Bulletin No.: 15-NA-029

Subject: Information on 1st Design / 2nd Design Transmission Shift Cables

| Brand:    | Model: | Model Year: |      | VIN: |    | Engine: | Transmission: |
|-----------|--------|-------------|------|------|----|---------|---------------|
| Chevrolet | Malibu | 2004        | 2004 |      |    |         | ME7 or MN5    |

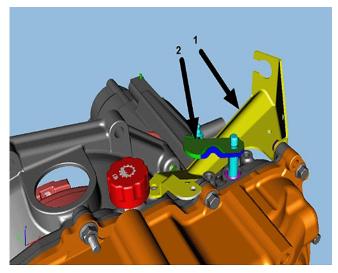
| Condition | On early build 2004 Malibu vehicles, the transmission shift cable may be longer than the current available through service parts and will not connect to the original shift cable bracket mounted on the transmission. |
|-----------|------------------------------------------------------------------------------------------------------------------------------------------------------------------------------------------------------------------------|
| Cause     | This may be due to some early built vehicles having the 1st design shift cable.                                                                                                                                        |

Install the new design shift cable and mounting bracket which has the revised cable routing, following the procedure below.

- 2. Remove the nut and bolt securing the shift cable bracket (1) to the transmission. Discard the nut, but retain the bolt for reuse.
- 3. Discard the shift cable bracket (1).
- 4. Remove and discard the shift cable lever nut and shift cable lever (2).

- 5. Install the new shift cable lever (2) to the transmission.
- 6. Install the nut to secure the lever.

- 7. Install the new shift cable bracket (1) to the transmission.
- **8.** Reinstall the bolt previously used to retain the vertical shift bracket fastener.

9. Install the bolt to the horizontal shift bracket fastener attachment.

Tighten: Tighten the nut to 30 Y (22 lb ft).

Tighten: Tighten the bolt to 25 Y (18 lb ft).

Tighten: Tighten the bolt to 25 Y (18 lb ft).
